Technical design note

Project name	Land North of Rectory Farm, Yatton		
Design note title	Response to IDB Comments dated 15th May 2023		
Document reference	23257-HYD-XX-XX-TN-D-0002		
Author	Richard Hughes		
Revision	P02		
Date	7 July 2023	Approved	✓

Point L - Wessex Water Sewer Map

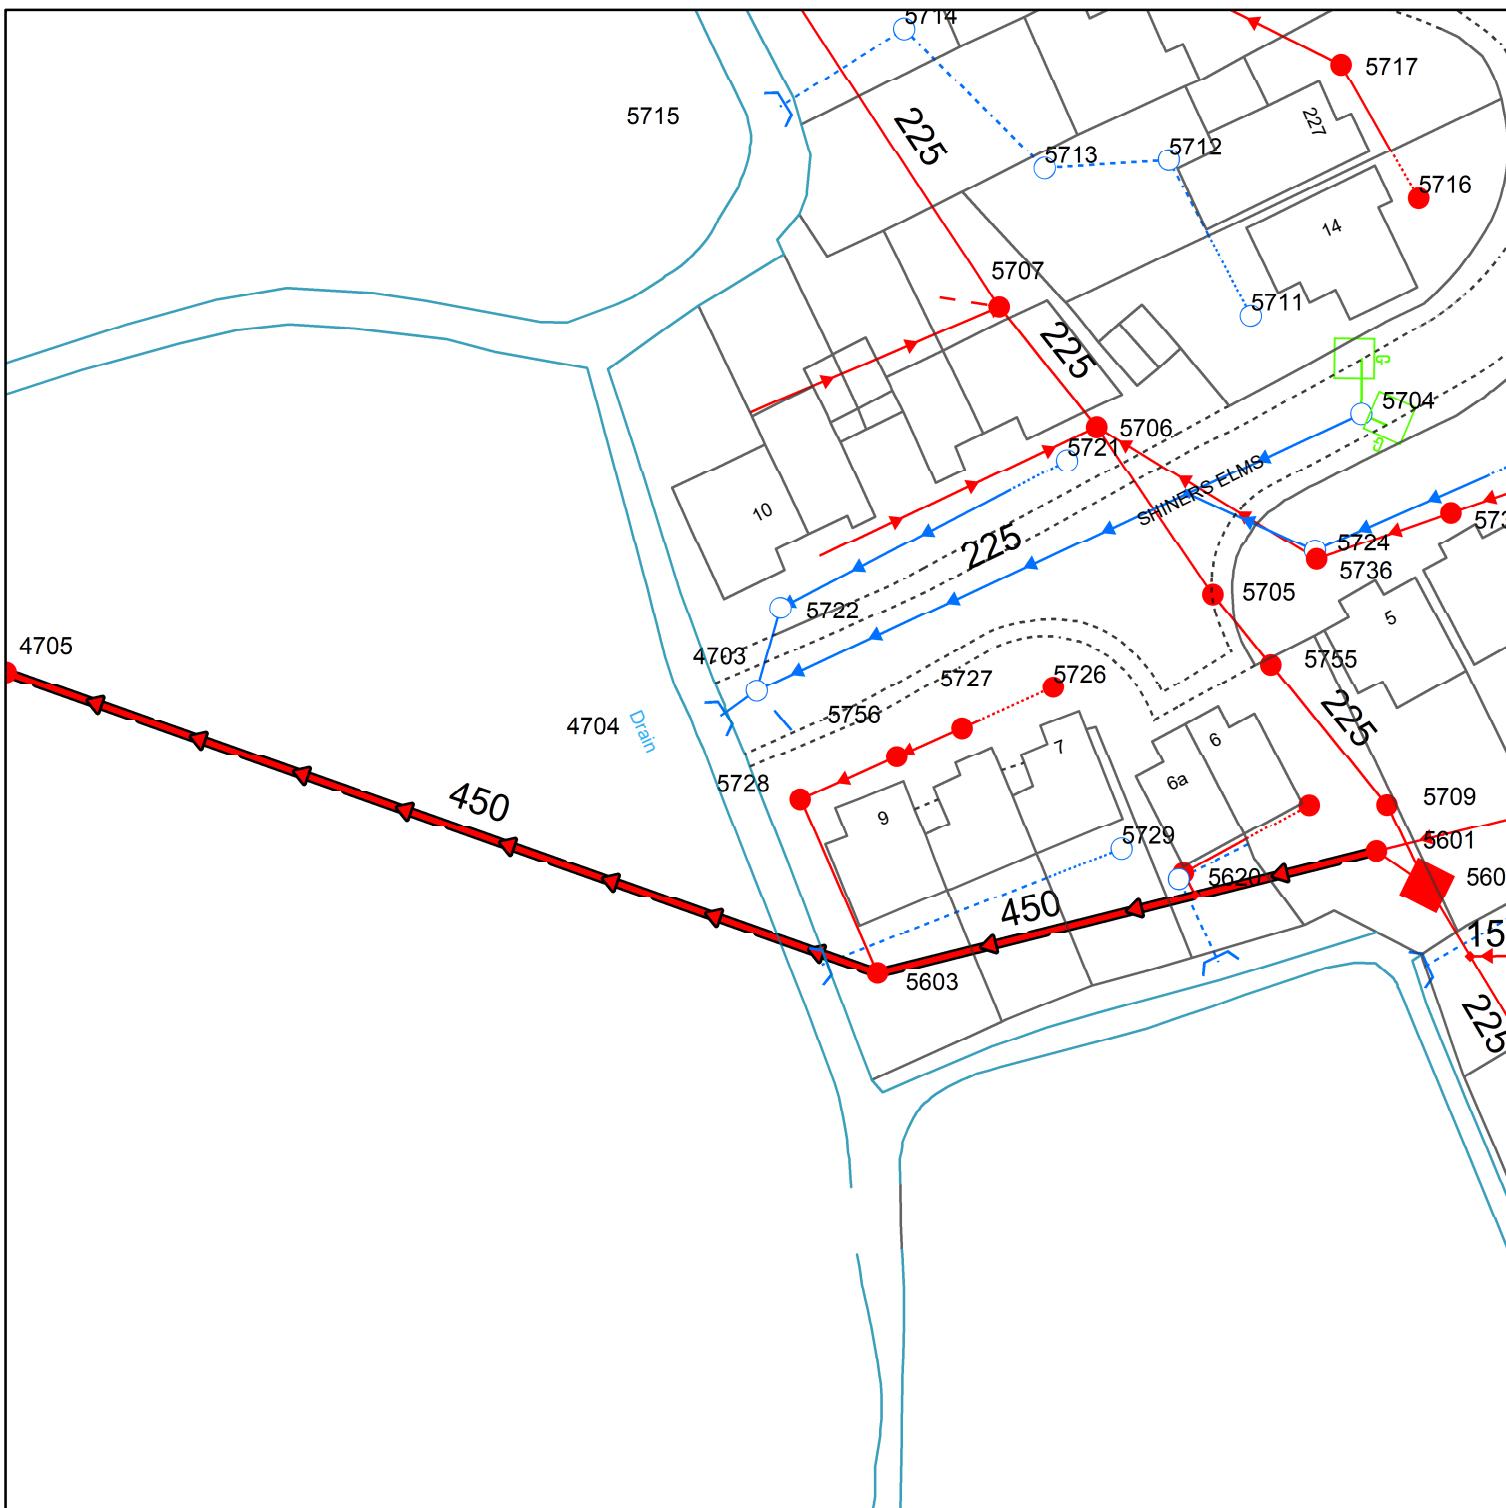
L My records show an extra outlet here.

Reference to the Wessex Water record plans show three private surface water outfalls in this area but no adoptable outfalls. It is not intended to carry out any works to the existing ditches in this area and the existing outfalls will be maintained.

A copy of the Wessex Water plan is included in Appendix F.
